Manor Road, Richmond

Addendum Flood Risk Assessment

6th September 2023

Post Development with Drainage

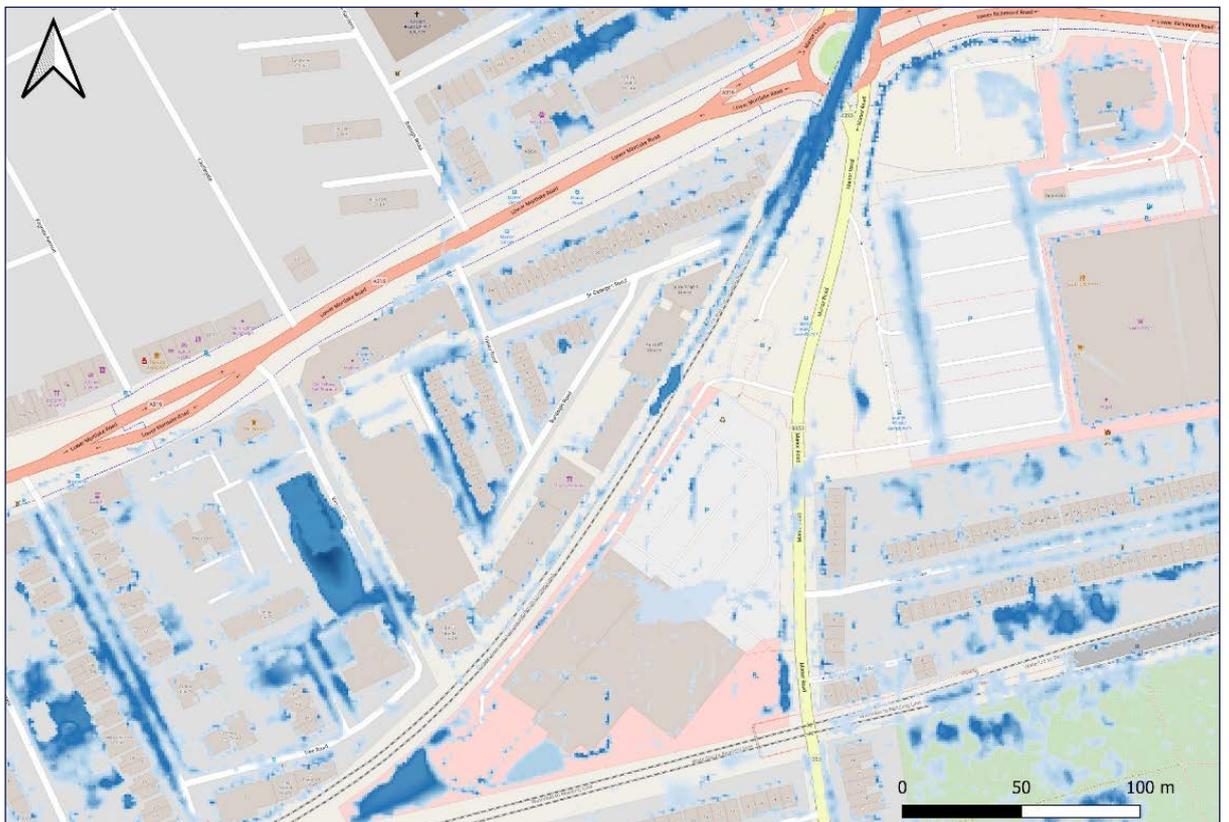
- 4.8** During consultation GLA and AECOM have raised a concern in relation to this increase being unacceptable and exceeding the industry standard modelling tolerance allowance of 10mm. It is noted that further technical notes have been provided but the LLFA's position remains unchanged and they would not be accepting of any offsite increase in line with policy requirements.

- 4.11** The outputs from this scenario demonstrate that when including the onsite drainage the flood extents and depths are significantly lower from the baseline scenario AND the 'no drainage' post development scenario details. To illustrate this the below figures both the baseline and the 'post development drainage' option. As can be seen there is a significant reduction and specifically to and along the railway line.

- 4.9** Further to the Hydrock modelling works and the consultation responses, Brookbanks have undertaken a further post development modelling scenario with a view of reducing / removing the off-site increase in flood depth. The approach for this scenario was to include the proposed surface water drainage strategy for the development into the model to understand what impact this has. The provision of the proposed drainage features is secured by planning condition and therefore must be delivered as part of the development. Consideration was given to include drainage within the wider area (i.e. surrounding road network) but to avoid any deviation from the EA's preferred methodology this was not progressed. Additionally, any off-site drainage network would be out of the site occupiers control and therefore it would not be their responsibility for management and maintenance and assurances couldn't be provided. On this basis, and to adopt a conservative approach, the sewers were assumed as 'full' for everywhere with the exception of the site.

- 4.10** In order to achieve this the proposed attenuation tanks and proposed sewer network (as per the submitted drainage strategy document) were built into the model. The boundary condition for this was modelled as a pumped system again to ensure consistency. Owing to a lack of available data no off-site drainage was included.

4.13 During the meeting held on 5th September, AECOM stated that there were accepting of the above option given that there was no detrimental impact as a result of the development and actually a significant increase.

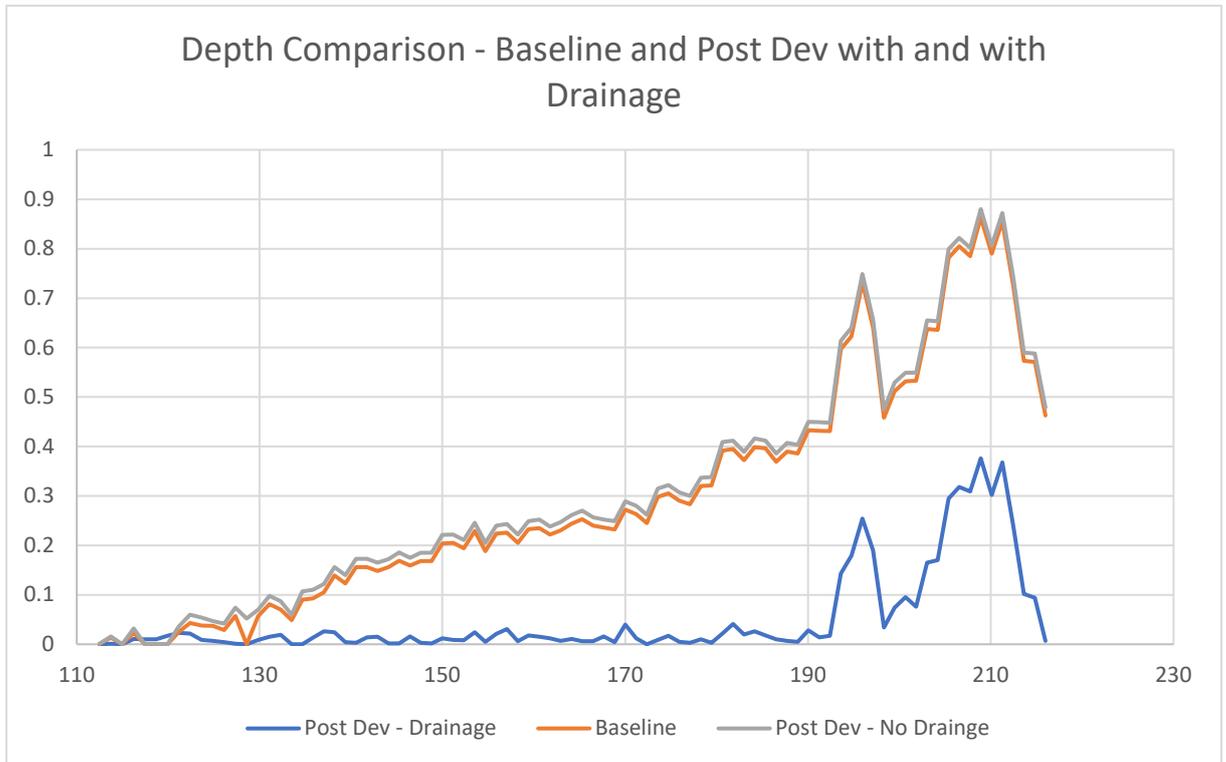
4.12 On comparison of predicted flood depths the on-site drainage results in a significant betterment and removes vast areas of flooding from the adjacent railway – with a maximum decrease compared to baseline of circa 250mm. It is reiterated that this difference is only when including the proposed site drainage and does not include any existing Thames Water sewers serving the surrounding area so would maintain as given conservative outputs. Along with the outlines a comparison graph showing the difference between the three events is shown below. These values have been taken running west to east along the railway line for the length of the site boundary.
